SITE PLAN REVIEW AND APPEARANCE BOARD STAFF REPORT

Meeting: January 9, 2019 File No.: 2018-013-SPM-SPR-CL3 Application Type: Delray Oasis Business Park

The action before the Board is the approval of a Class III Site Plan Modification application associated with building use conversions, expansion of parking lot, site improvements, and architectural elevation changes for the Delray Oasis Business Park project pursuant to LDR Section 2.4.5 (G)(1)(c), including the following:

L-3

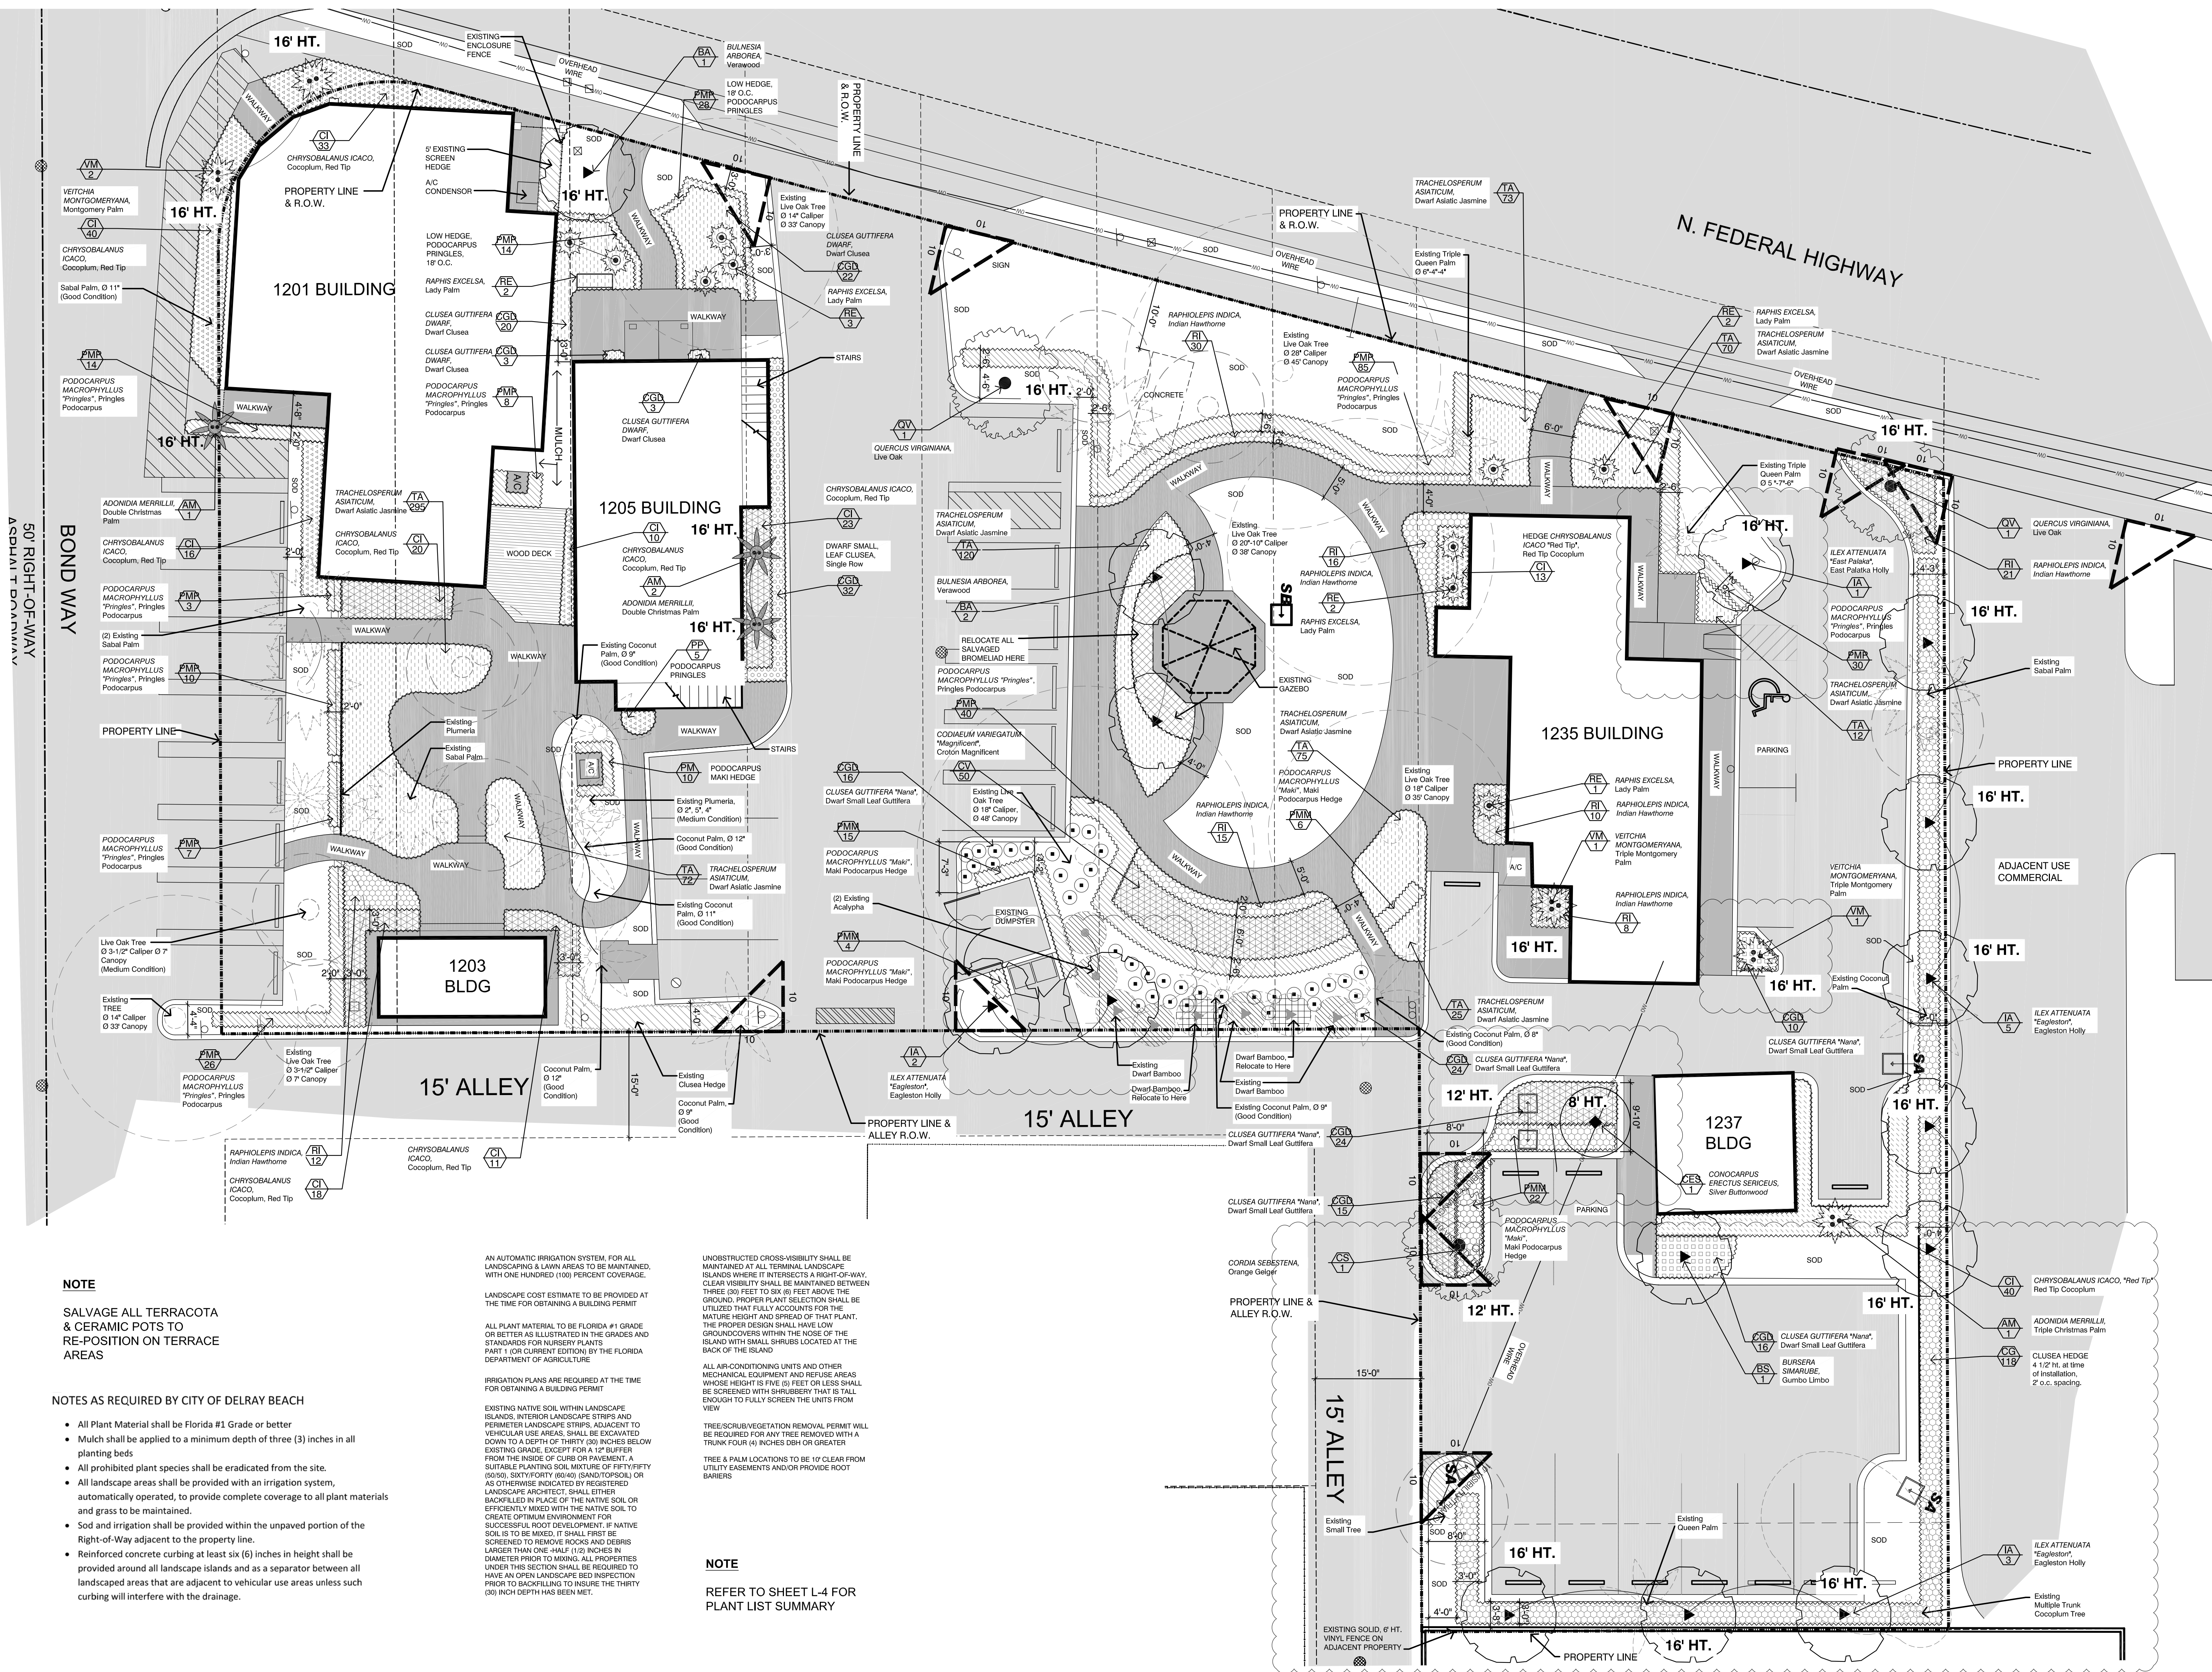
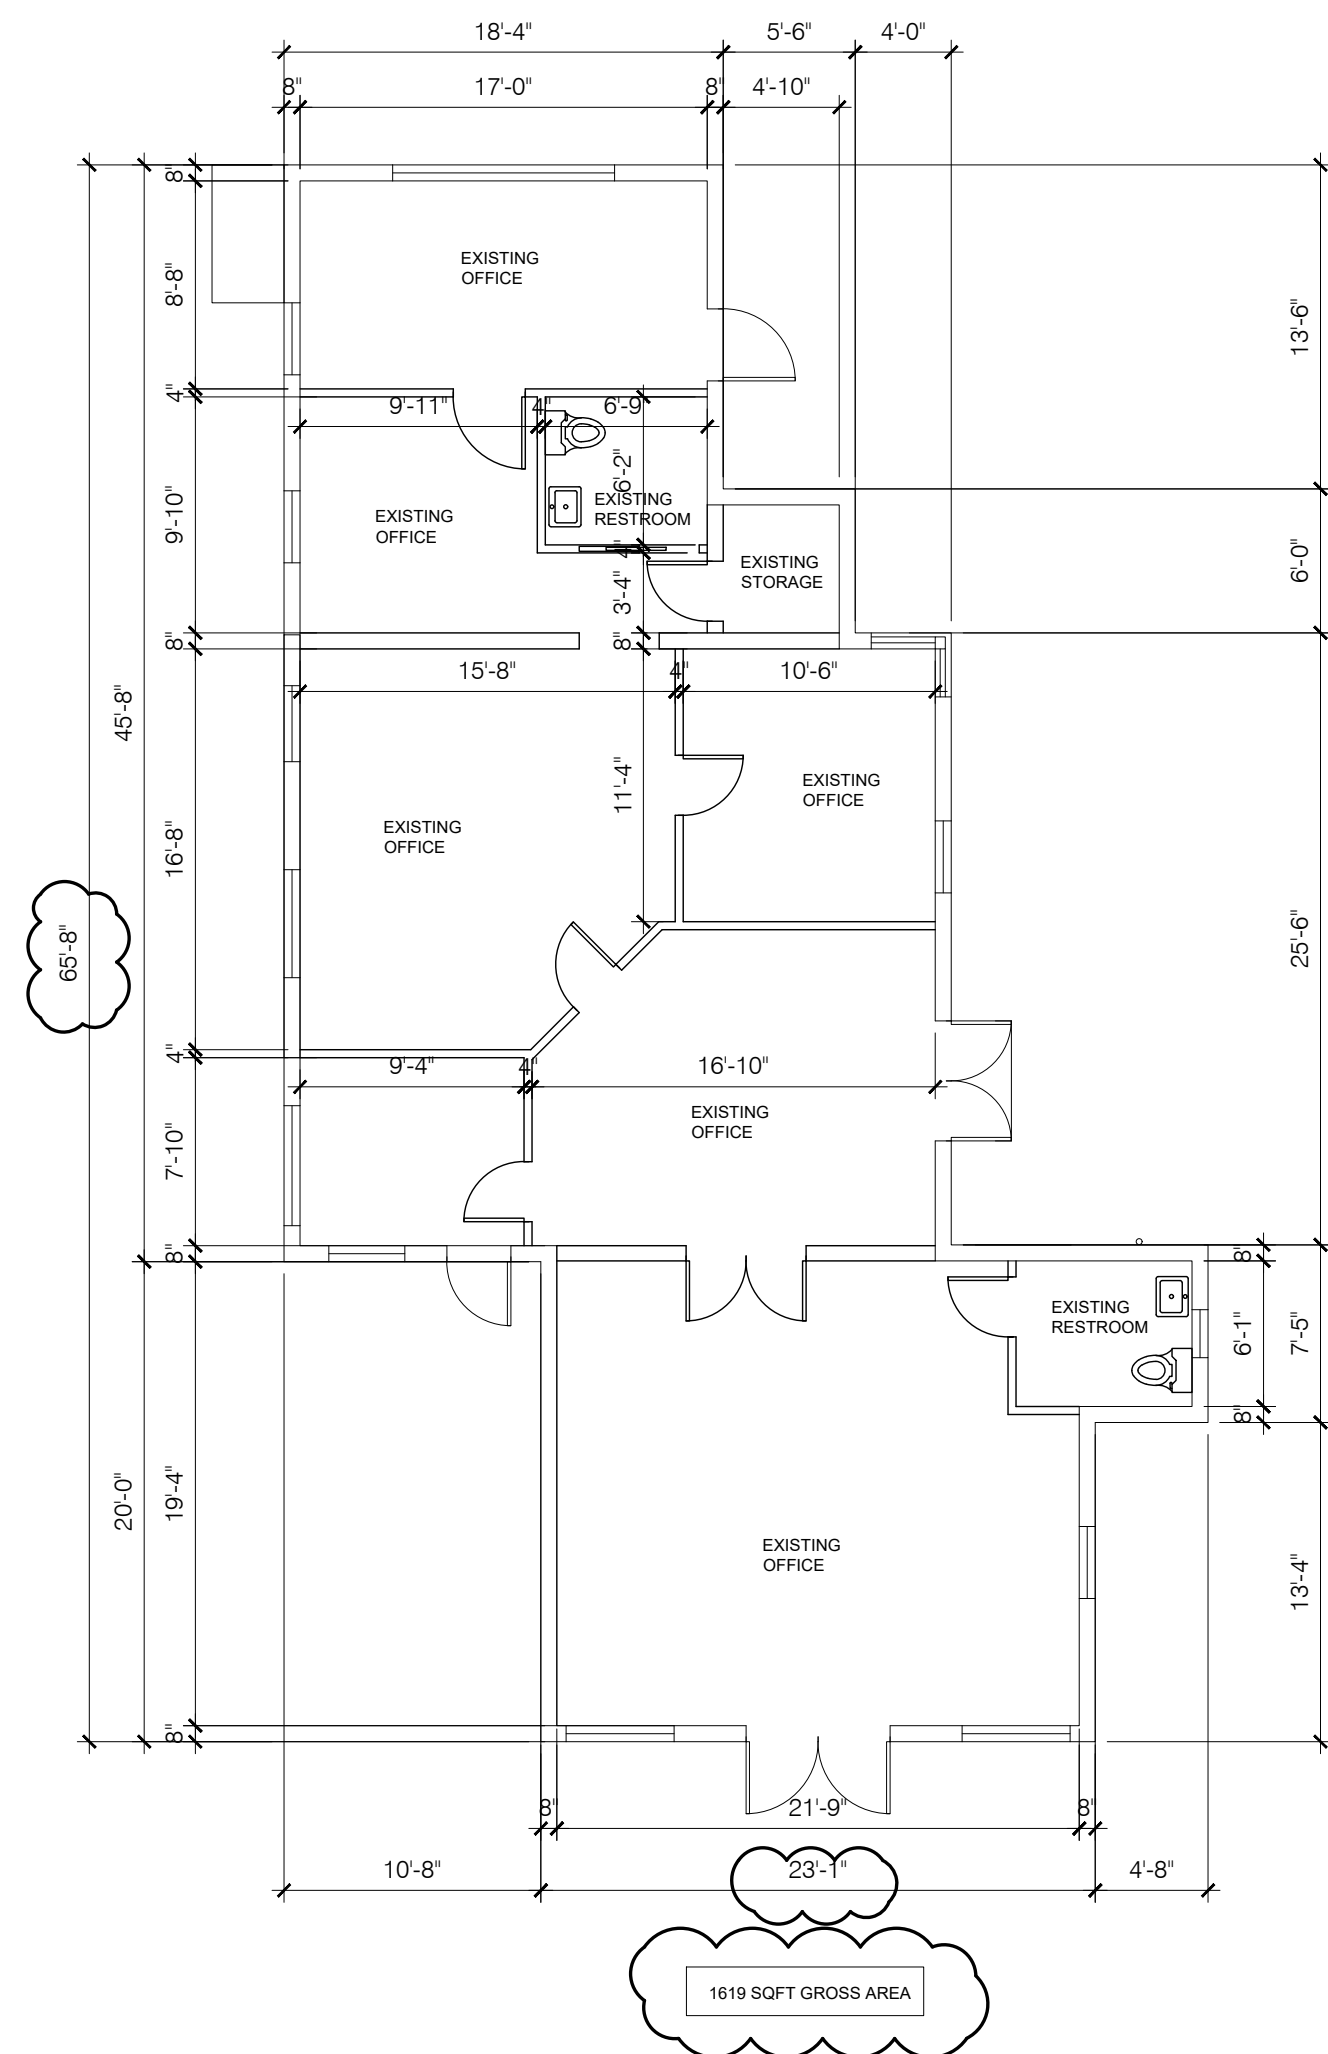
- (a) Provide for perimeter landscaping adjacent to public rights-of-way to screen vehicular parking.
 - ✓ Landscape plan L-3 proposes a 4.5' high continuous row of shrubs, and a row of trees to create a 3'-8" landscape buffer at the new parking area adjacent to the low-density residential property.
- (c) Provide landscape screening at all dumpsters, refuse areas and ground mounted air-conditioning units.
 - ✓ Landscape plan L-3 and L-4 proposes a row of Maki Podocarpus hedges around the dumpster enclosure and ground mounted ac units; thus, this requirement has been met.
